RE: JMC Project 19124
#100-Building 2
100 Business Park Drive
Town of North Castle, NY

Response to Town Comments Submission

Town of North Castle Planning Department Memorandum, dated April 10, 2020

**SOUTHERNMOST LOADING DOCK
WB-67 ENTERING MOVEMENT**

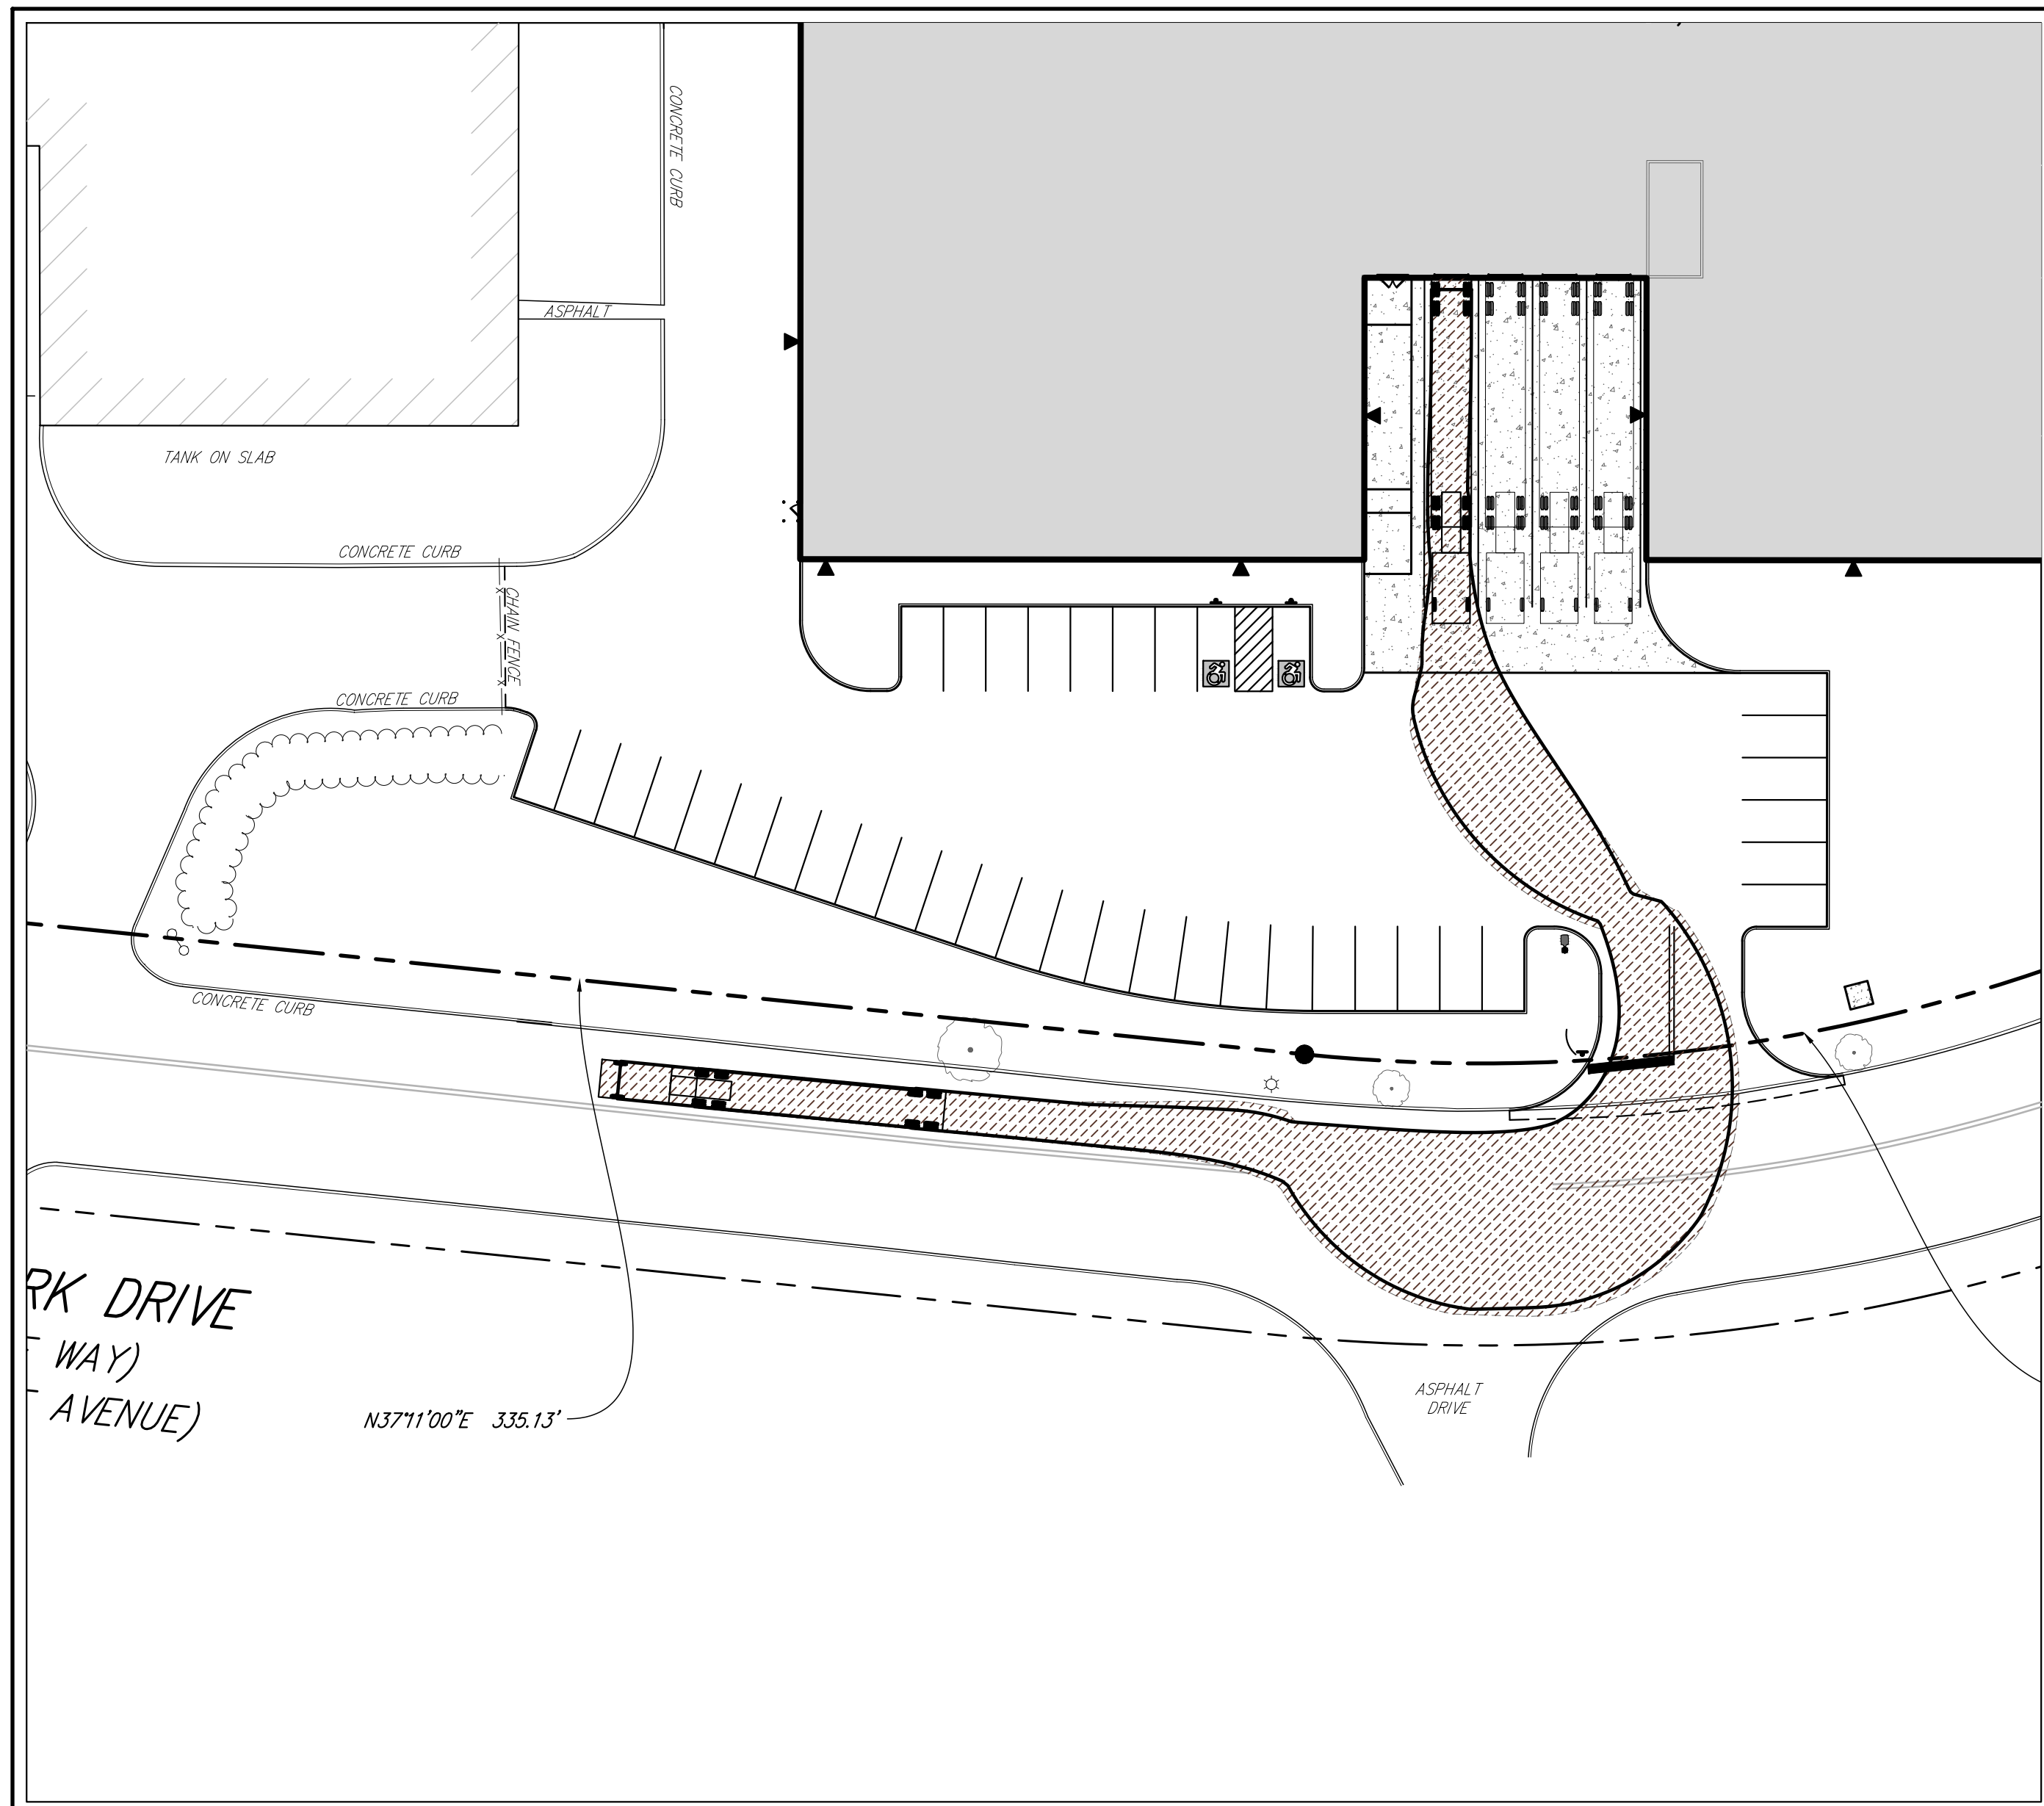
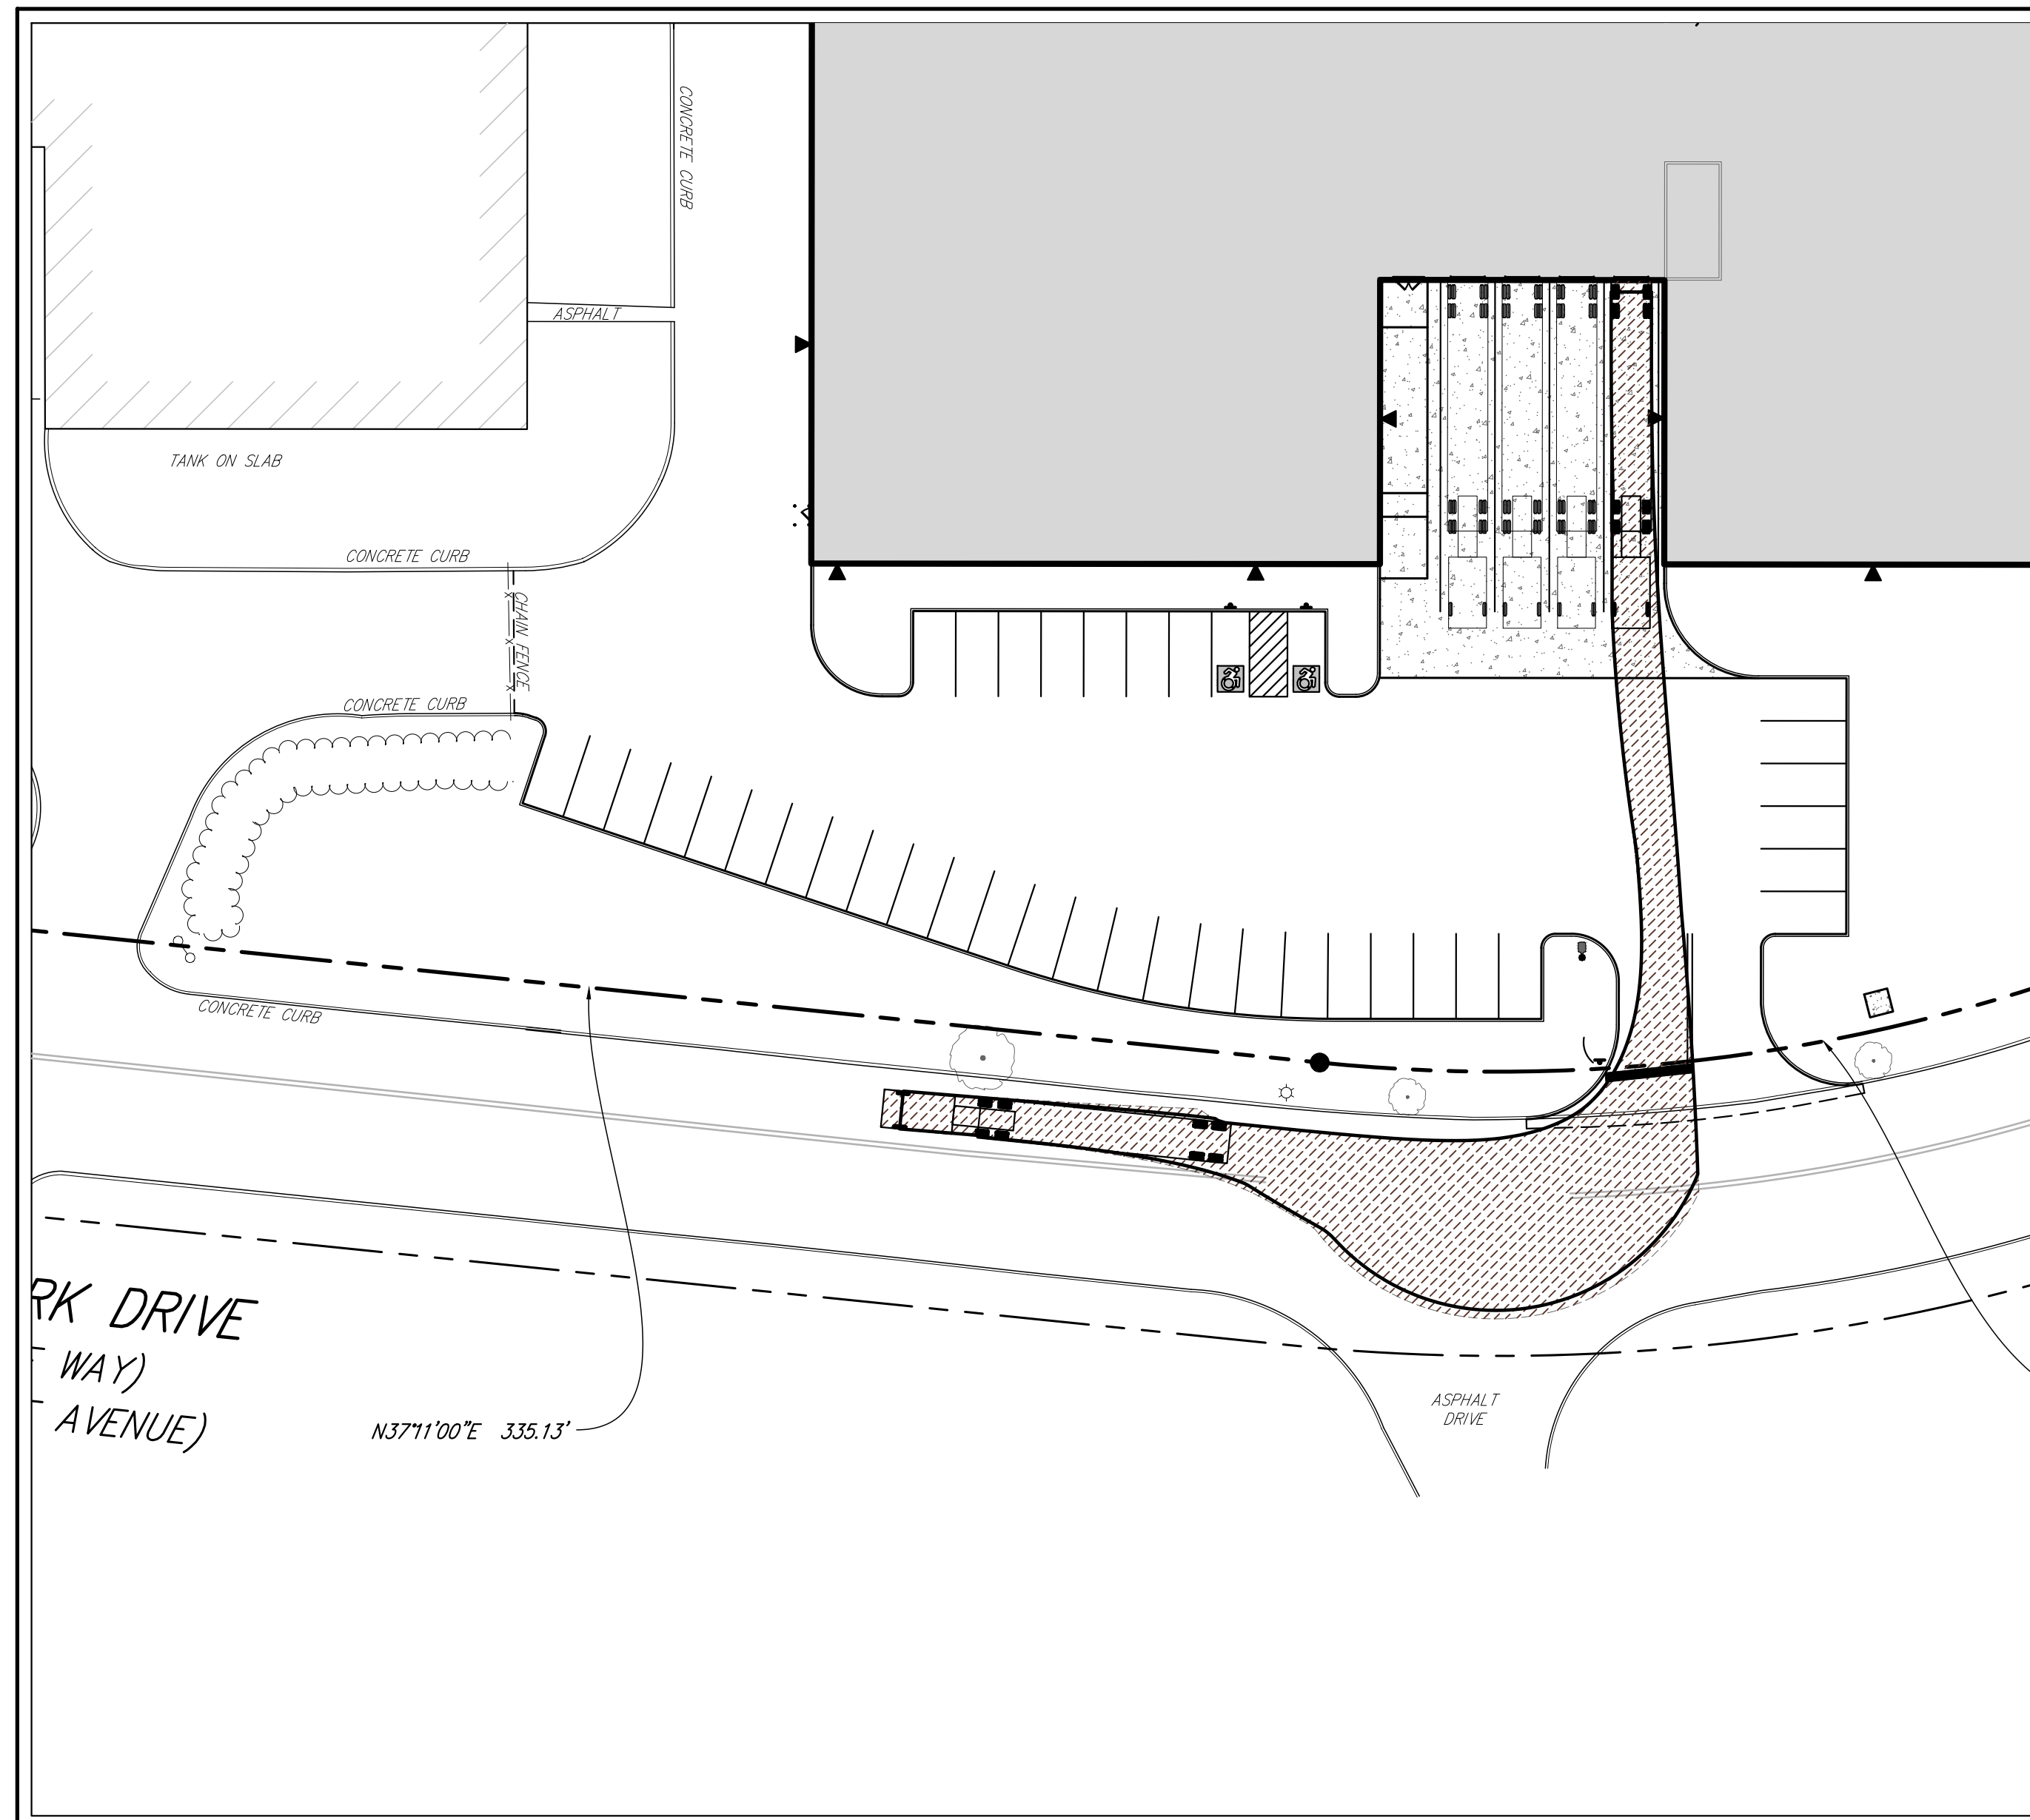
The plan proposes a total of eight (8) loading docks at the front of the proposed warehouse building, four (4) of which are shown as tandem spaces. The applicant should provide vehicle turning movements for the size trailer anticipated to access the site to demonstrate adequate maneuverability into the site and accessing these loading areas.

The site plans have been revised to depict delivery truck (WB-67) vehicle turning analyses demonstrating adequate maneuverability into the site and accessing the loading areas.
